# CITY OF APPLETON

## MEMORANDUM

**Date:** July 23, 2025  
**To:** Plan Commission  
**From:** Lindsey Smith, Principal Planner  
**Subject:** Preliminary Plat – Mission Ridge North

# Mission Ridge North Subdivision

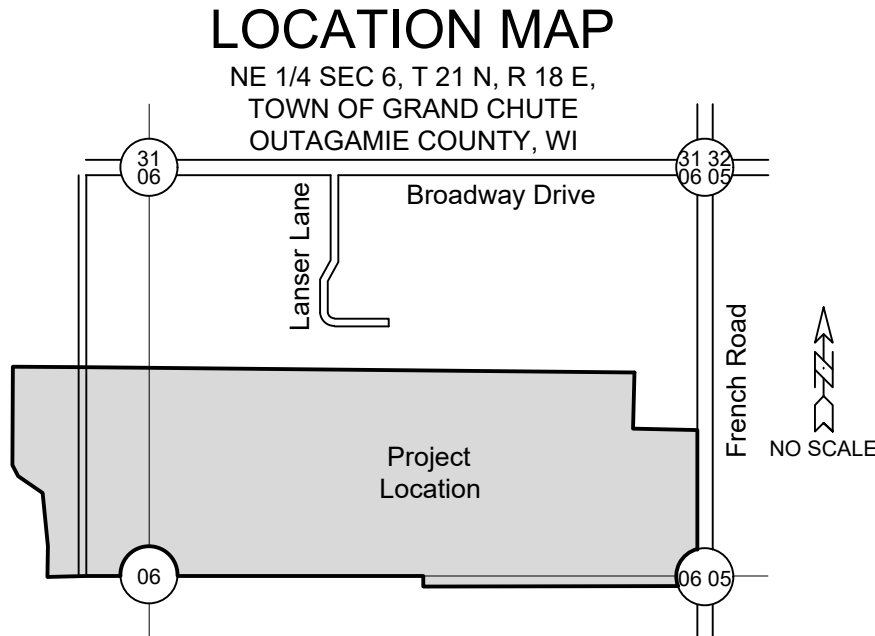
- Analysis: Lots 1-8, Outlots 4 are located in floodfringe areas and will be removed from floodplain by filling. This requirement and placement of fill will be reviewed and verified through the building permit review process for new home construction on the applicable lots.*

- It appears, Outlot 2 does not satisfy the minimum 7,000 square foot lot size requirement of the R-2 Zoning District. Outlot 1 and 2 does not comply with Section 17-26(f) requiring corner lots to be sufficient width to provide usable rear yard. Prior to Final Plat approval, Outlot 1 and 2 shall comply with Section 17--3(c)(6), 23-95(g), and 17-26(f) of the Municipal Code or add a note on the plat specifying, "the lot is not buildable at this time as it does not meet the requirements per the Appleton Municipal Code."

**Dedication of Public Parks and/or Trails or Payment Fee in Lieu Thereof:** The City of Appleton Trail Master Plan (2017), and amended in 2020, proposed network map identifies a proposed trail within Outlot 3. However, Parks and Recreation staff are uncertain if TC Energy will authorize the City to construct a public trail within the gas line easement. The City recommends a 30' easement being shown for future trail rather than dedication of Outlot 3.
